City of Denton

Meeting Agenda Planning and Zoning Commission

Wednesday, May 13, 2026

- A. [FP26-0012b](#) Consider a request by Mack Mattke of Kimley Horn & Associates on behalf of CATDENTON 35 for a Final Plat of Summit 35 Addition. The approximately 68.175-acre property is generally located east of North Interstate 35, north of Loop 288, and southwest of Highway 77 (North Elm Street) in the City of Denton, Denton County, Texas. (FP26-0012b, Summit 35, Julie Wyatt)

Scale	Drawn by	Checked by	Date	Project No.	Sheet No.
1" = 250'	JCC	KHA	APRIL 2026	063226937	1 OF 12

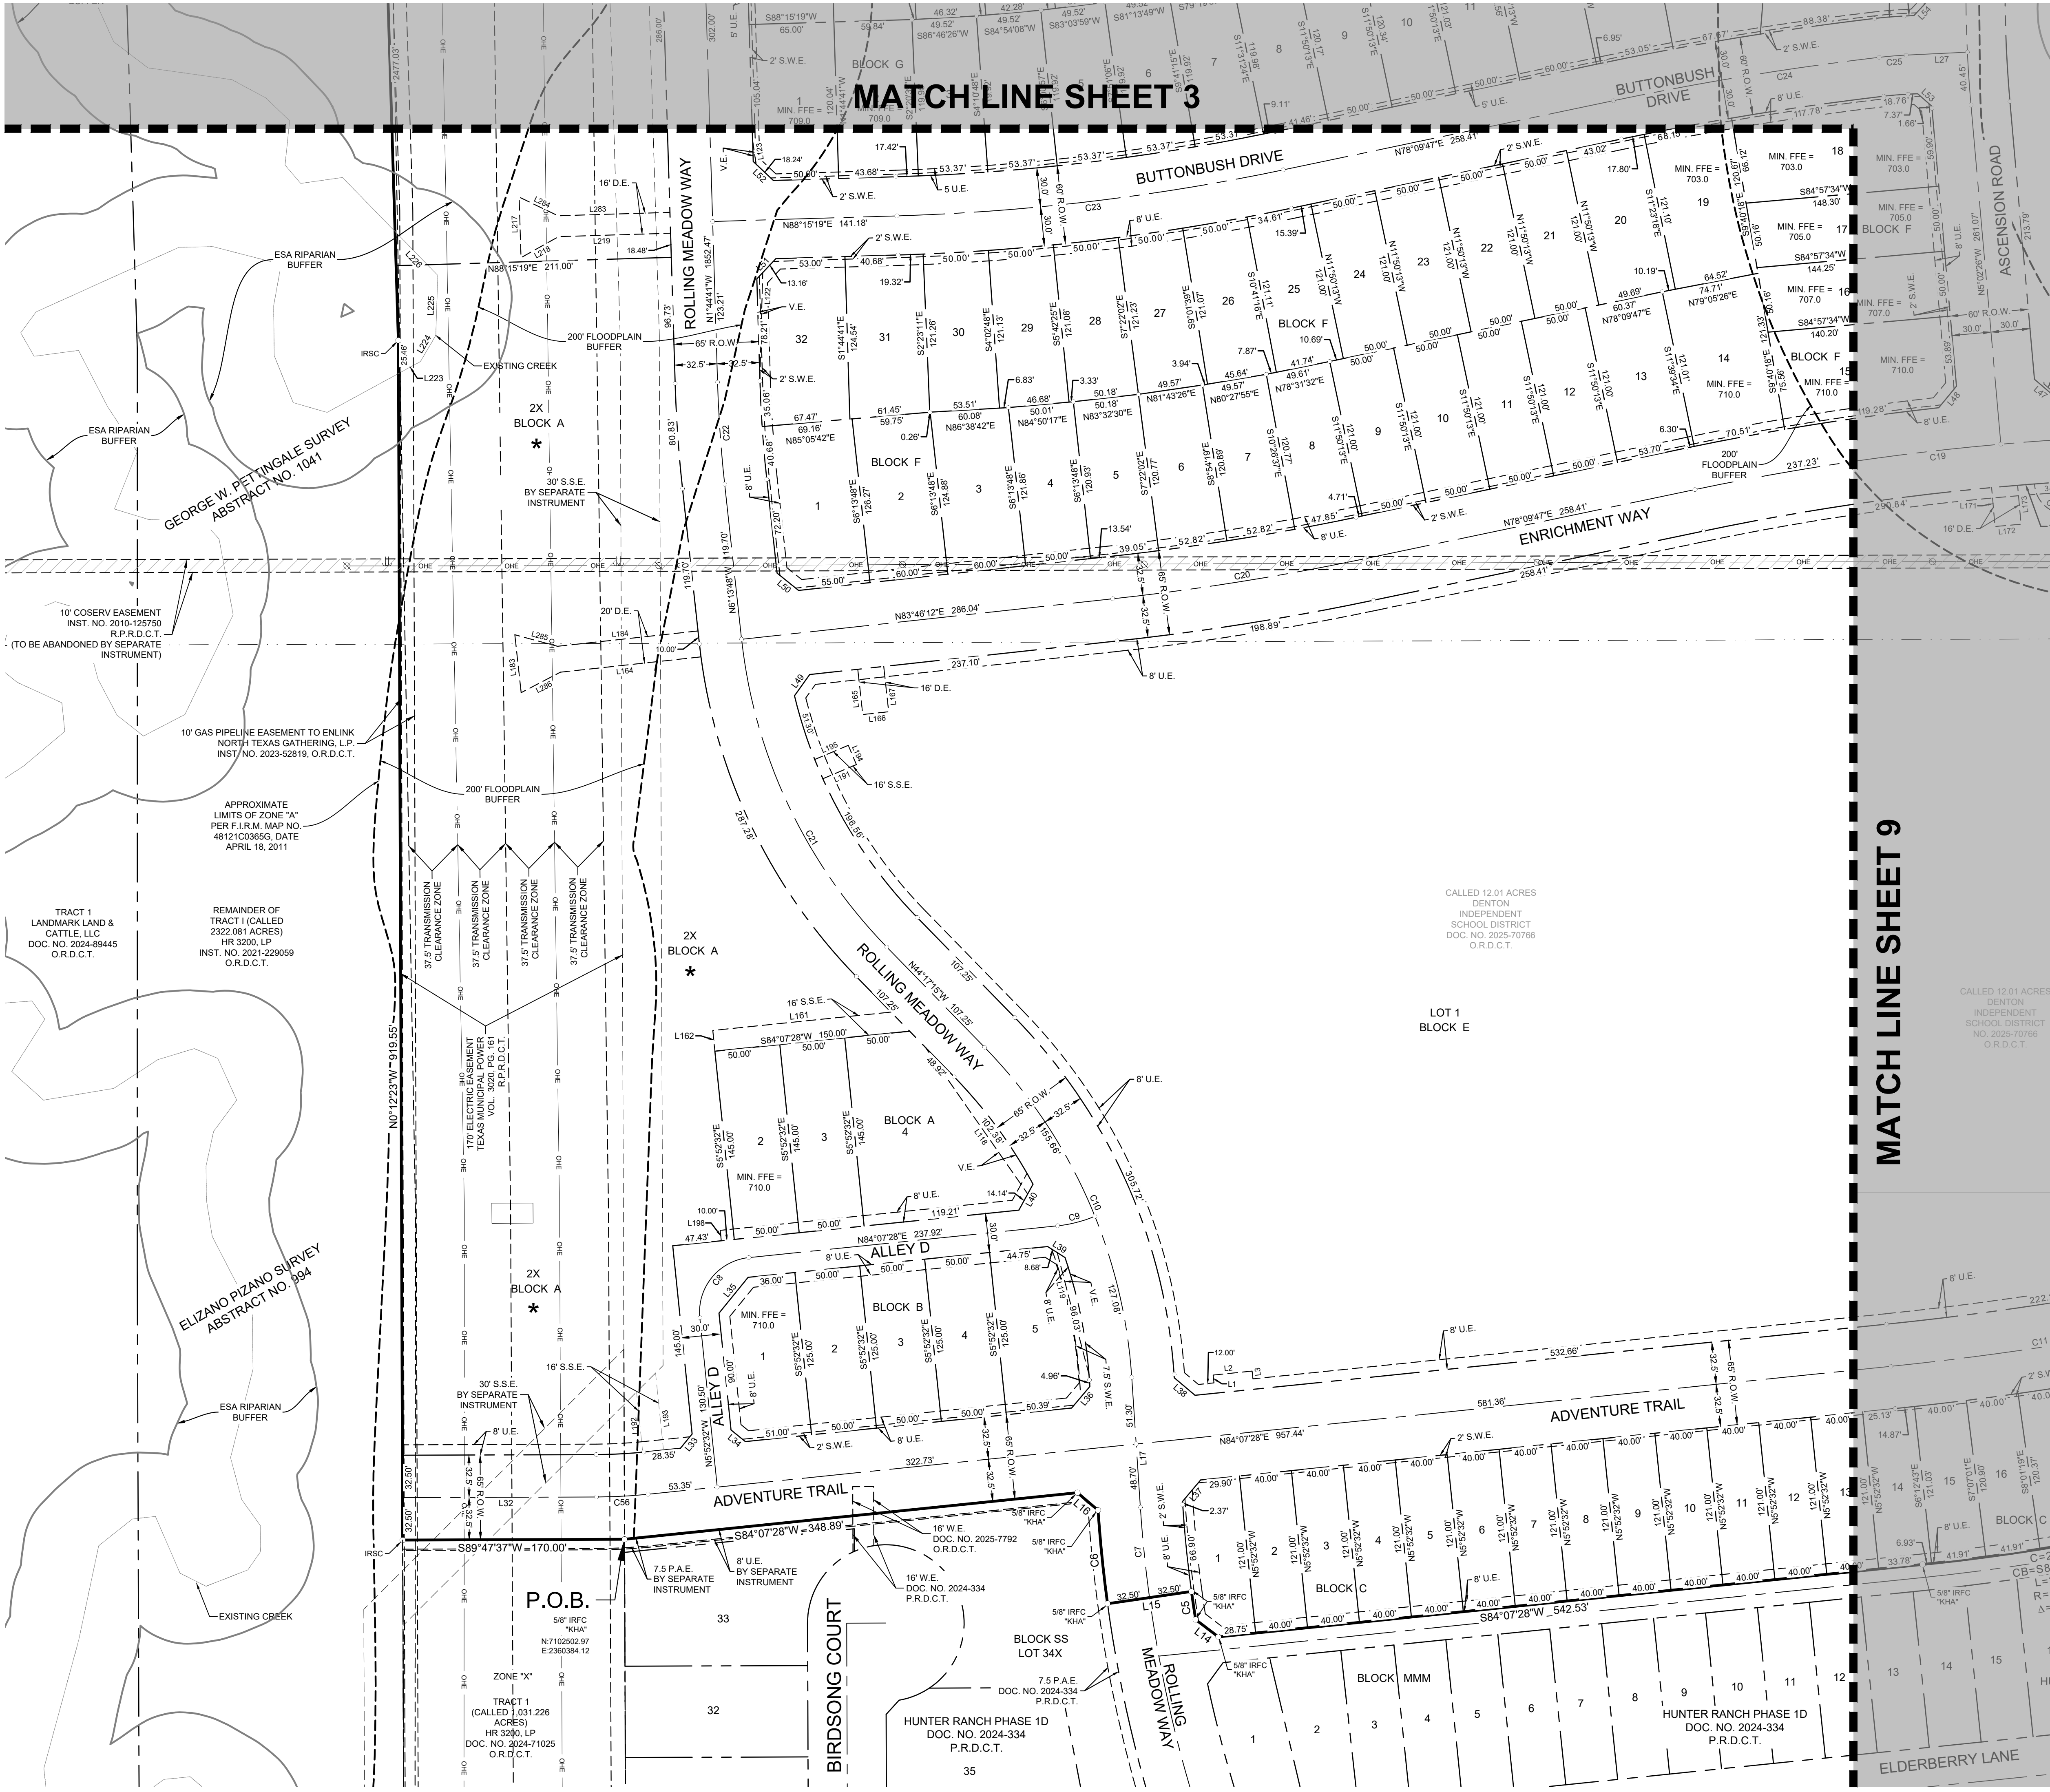
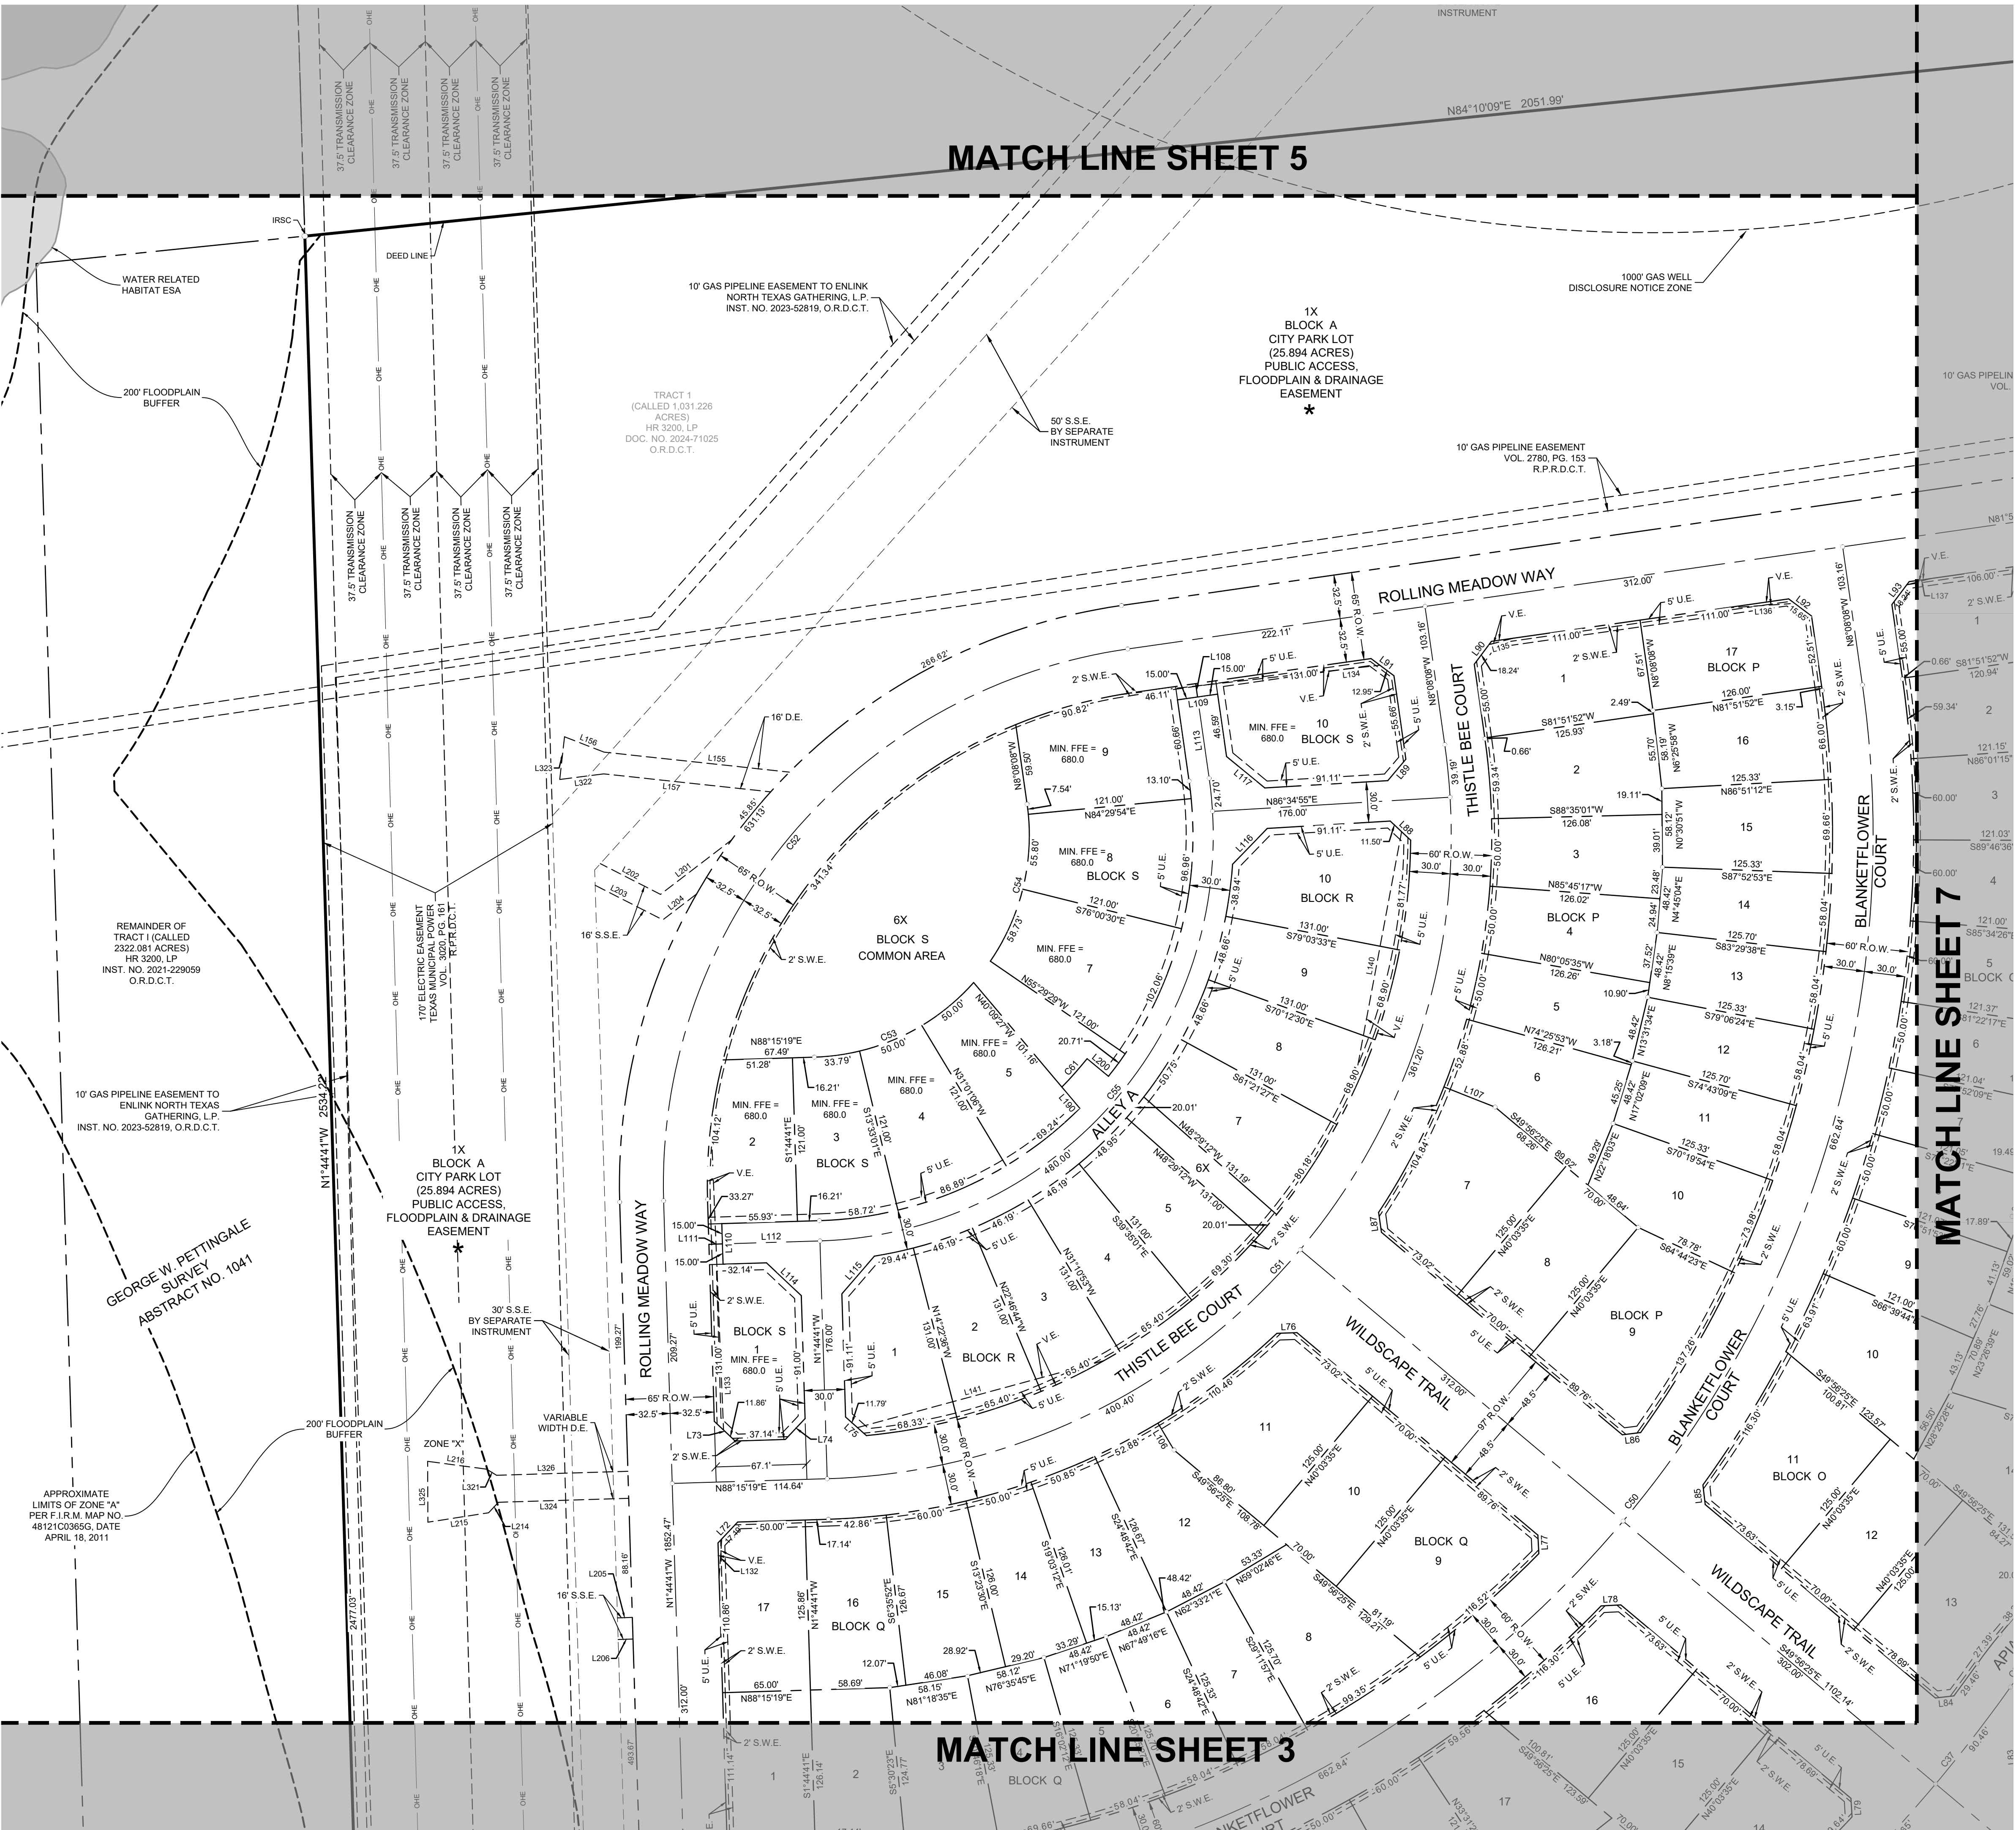
1. Compliance with MPC19-0002c 2.11.4C.2.d, which requires final approval of the Civil Engineering Plans (CEP25-0082), must be achieved prior to final approval.

1. Compliance with MPC19-0002c 2.11.4C.2.d, which requires final approval of the Civil Engineering Plans (CEP25-0082), must be achieved prior to final approval.

4. Compliance with this DDC				
a. The proposed development shall comply with all applicable standards in this DDC, unless the standard is to be lawfully modified. Findings:		☐	☒	☐
